Access Compliance Report

Public Rights-of-Way

Intersection ID: 27495	Main Street: BALLANTYNE COMMONS PY	Cross Street: NORTH COMMUNITY HOUSE RD	Location: SE
ADA ID: DA0E7138AABC	Ramp Type: Perp	Initial Pass/Fail: Fail	Overall Compliance: No
		Severity Score: 8.75	
Codes/Mitigation Info/Possible Solution		Field Measurements/Component Compliance

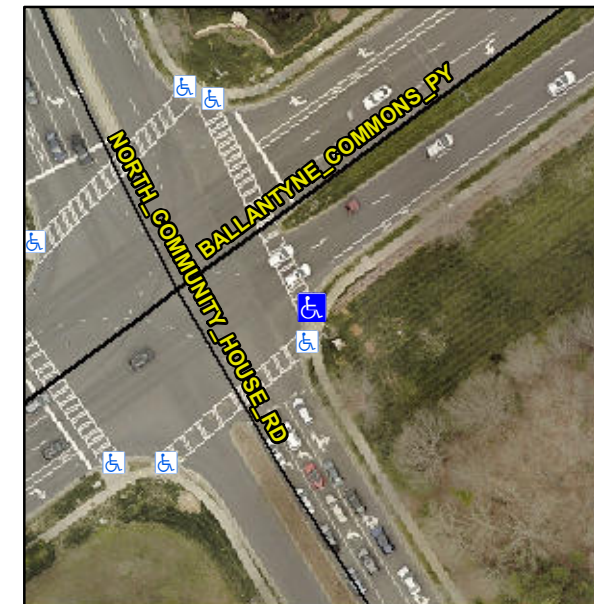
Not Found, R304.5.1

Compliance	Description	Data	Compliance	Description	Data
N/A	Ramp Length (in)	110.0	Yes	Ramp Slope (%)	6.0
No	Ramp Width (in)	45.0	Yes	Ramp XSlope (%)	1.9
N/A	Flare Type LT	N/A	N/A	Flare Type RT	N/A
N/A	Flare Slope LT (%)	N/A	N/A	Flare Slope RT (%)	N/A
N/A	Flare Traversable LT?	N/A	N/A	Flare Traversable RT?	N/A
N/A	Landing Length (in)	N/A	N/A	DWS Provided?	N/A
N/A	Landing Width (in)	N/A	N/A	DWS Contrast?	N/A
N/A	Landing Slope (%)	N/A	N/A	DWS Length (in)	N/A
N/A	Landing X Slope (%)	N/A	N/A	DWS Full Width?	N/A
N/A	Landing Curb? (Y/N)	N/A	N/A	DWS Offset (in)	N/A
N/A	Shared Landing?	N/A			
N/A	Gutter Ponding?	N/A	N/A	Gutter Slope (%)	N/A
N/A	Gutter Lip Ht (in)	N/A	N/A	Gutter X Slope (%)	N/A
N/A	Painted X Walk1?	Yes	N/A	Painted X Walk2?	N/A
	X Walk 1 Direction	To NW		X Walk 2 Direction	N/A
N/A	X Walk 1 Width (in)	125.0	N/A	X Walk 2 Width (in)	N/A
	X Walk 1 Slope (%)	5.8		X Walk 2 Slope (%)	N/A
	X Walk 1 X Slope (%)	3.2		X Walk 2 X Slope (%)	N/A

Remove & Replace Entire Ramp.
